# Attachment 3

Response to  
IESC Advice

## WINCHESTER SOUTH PROJECT Environmental Impact Statement Additional Information

**Table A3-1**  
**Reconciliation of Comments from the Independent Expert Scientific Committee on Coal Seam Gas and Large Coal Mining Development**

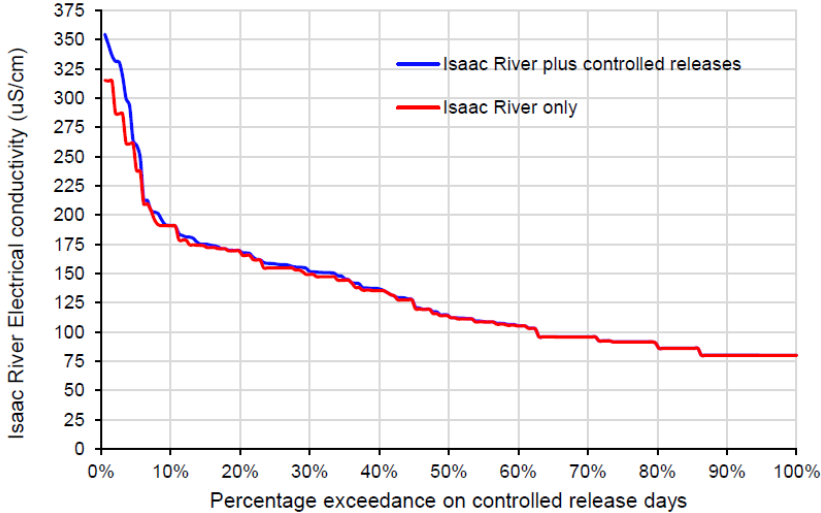
Recommendation/Comment	Response
	<p>Site C14 located slightly closer to the identified Brigalow TEC indicated a boundary of soil mapping unit S1 (i.e. Brown texture contrast loamy soils on gently undulating plains) and soil mapping unit C1-BR (i.e. Moderate to deep brown clay soils on flat plains with melon hole microrelief [gilgai]) was present.</p> <p>The conceptual model case study series ‘Gilgai wetlands’ demonstrates consistencies with observations and conclusions drawn by the technical assessments for the Project, indicating that the area of Brigalow TEC identified is likely accessing water held within the clay-rich gilgai depressions for extended periods of time following rainfall events. Further to this point, Johnson (1964) describes that Brigalow has a well-developed lateral (horizontal) root system, and plants are often joined together by these roots which form colonies. Considering that depth to groundwater within the Project area is typically greater than 30 to 40 m, it is unlikely that the Brigalow TEC is accessing groundwater at such a depth.</p> <p><b><u>Queensland Government Pre-clearance Regional Ecosystem Mapping</u></b></p> <p>Pre-clearance regional ecosystem mapping indicates that regional ecosystems known to be associated with Brigalow TEC (DAWE, 2021) occurred extensively across the Project Area prior to clearing. The extent of the associated regional ecosystems coincides with both the location of the identified Brigalow TEC and the extent of Gilgai soils mapped by the Soils and Land Suitability Assessment for the Draft EIS. To this end, it is likely that clearing for agricultural land use practices, rather than groundwater reliance has resulted in the decline in potential Brigalow extent over the Project Area.</p> <p><b>TEM Surveys</b></p> <p>TEM Surveys were undertaken across representative wetland and potential GDE areas within the Study Area. Consistent with the findings of Johnson (1964), and Jones (2019), TEM surveys within the Study Area indicated that wetlands and potential GDE’s were underlain by a clay layer. These clay-rich layers create a perched aquifer within the geological profile, located well above the water table, and are disconnected from the surrounding groundwater regime.</p> <p><b>Conclusion</b></p> <p>The above studies and additional investigations continue to justify the position that further studies of potential groundwater dependency are considered unnecessary on the basis that the outcomes of comprehensive assessments undertaken for the Project preclude vegetation communities within the Project area from forming GDEs, or, otherwise where there is potential for GDEs to occur, conclude that the Project is unlikely to facilitate material impacts due to changes in groundwater quality or resource.</p> <p>In view of the above, further field studies of potential GDEs are considered unnecessary as the likelihood of groundwater dependency has been concluded.</p>

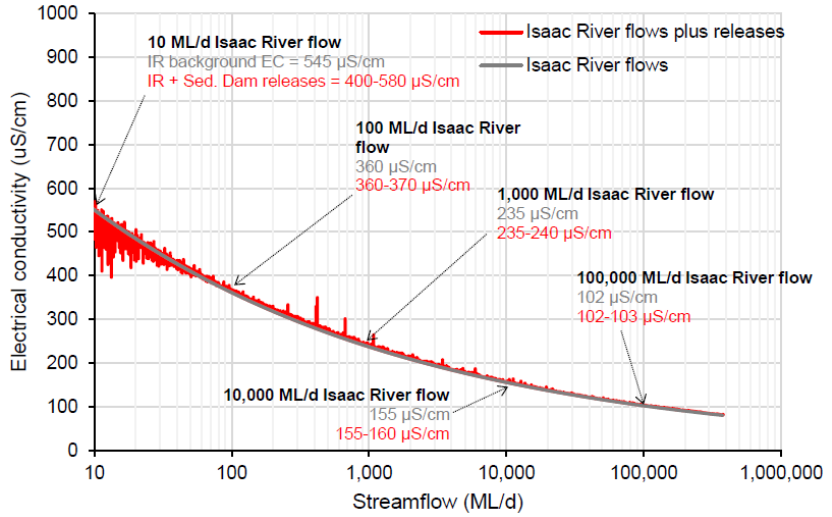
<p>33. Removal and diversion of some 16 km of ephemeral creeks in the project area will also alter stream flow regimes, especially ecologically important flow components such as the numbers of zero- and low-flow days, along the lower reaches of these streams down to where they join the Isaac River. Changes in flow regimes in ephemeral creeks have major repercussions for the biodiversity and composition of their aquatic and riparian communities (Datry <i>et al.</i> 2017) but these potential impacts are not discussed by the proponent. The reduced flows in the lower reaches may also reduce recharge of local alluvial groundwater, potentially affecting the condition of groundwater-dependent vegetation in the riparian zone and nearby floodplain and detracting from habitat values for arboreal wildlife such as Koalas and Greater Gliders. Reduced alluvial recharge may also have impacts on stygofauna and other GDEs in the local area. The proponent should fully assess these potential impacts on water-dependent assets, especially those impacts that will persist after mining finishes.</p>	<p>An area of approximately 13.7 km<sup>2</sup> would report to the residual voids at the completion of mining. The changed topography following completion of the Project would have the following impacts on catchment areas:</p> <ul style="list-style-type: none"> <li>• The catchment draining to the Isaac River (to the confluence of the Isaac River and Ripstone Creek) would reduce by approximately 13.7 km<sup>2</sup> (compared to pre-mining conditions), a decrease of less than 0.3%.</li> <li>• The catchment draining to Ripstone Creek would reduce by approximately 4.3 km<sup>2</sup> (compared to pre-mining conditions), a decrease of less than 1.5%.</li> </ul> <p>The loss of catchment flows in the Isaac River and Ripstone Creek would be indiscernible, and as such the potential impact on water quantity in Isaac River and Ripstone Creek due to the final landform is considered negligible (WRM, 2022) (Attachment 6 of the Additional Information). Therefore, unlikely to affect the alluvial groundwater recharge. As such there will be no impact to instream, riparian and floodplain eco-systems.</p> <p>The Aquatic Ecology and Stygofauna Assessment for the optimised Project (ESP, 2022) (Attachment 10 of the Additional Information) concluded:</p> <p><i>The Project area represents less than 0.05% and 0.3% of the overall catchment areas for the Fitzroy River basin and the Isaac-Connors sub-basin, respectively. The changed topography as a result of the Project final landform would reduce the catchment area draining to the Isaac River compared to pre-mining conditions; however, the decrease in catchment area is expected to be less than 1.5% (WRM 2022). No measurable impacts to surface water quantity are likely to occur as a result of the Project (WRM 2022). Therefore, the loss of catchment area is minor in a regional context.</i></p> <p><i>Regardless of this change to the captured catchment area, no measurable impacts to surface water quantity are likely to occur as a result of the Project (WRM 2022). ... Therefore, impacts to surface flows and subsequently aquatic ecosystems downstream of the Project area are not expected.</i></p> <p>Modelling has shown that the optimised Project would result in negligible increased leakage from surface flows of the Isaac River to the underlying alluvium.</p>

Recommendation/Comment	Response
	<p>The change in flows as a result of the increased hydraulic gradient between the alluvium and the Isaac River would be a negligible reduction in average flow when the Isaac River flows; therefore, impacts to surface flows and subsequently aquatic ecosystems downstream of the Project area are not expected. The optimised Project is likely to result in fewer impacts (proportionally) on baseflow contributions to New Chum Creek, North Creek or Cherwell Creek given the distance of these waterways from the Project (SLR Consulting, 2022) (Attachment 5 of the Additional Information). Further to this, there is limited interaction between drawdown in the Layer 1 (Alluvium) and Layer 2 (Regolith) and Isaac River, Cherwell Creek, Ripstone Creek, unnamed ephemeral tributaries.</p>
<p>34. The IESC notes that there is an area of highly erosive and dispersive soils to the northeast of the mining lease by the railway pit release point (compare Whitehaven Coal 2021, App. B, App. F, p. 36 to Whitehaven Coal 2021, App. B, p. 144). The proponent does not appear to have discussed the potential risks of impacts on aquatic ecosystems such as Cherwell Creek that may receive runoff from this area. Additional field surveys of aquatic biota are recommended in this area to identify any potential risks and serve as baseline data for future surveillance monitoring.</p>	<p>Cherwell Creek is upstream (and majority is upland) for the Railway Pit, and the proposed controlled release point, and therefore there would be no mechanism to receive run-off from these areas or release point.</p> <p>Notwithstanding, controlled releases would only be required when river flow is more than 400 times larger than the controlled release flow. As such, the minimum dilution ratio (the daily volume of the Isaac River flow divided by the daily volume of controlled releases to the Isaac River) required for a controlled release into the Isaac River is 407.</p>
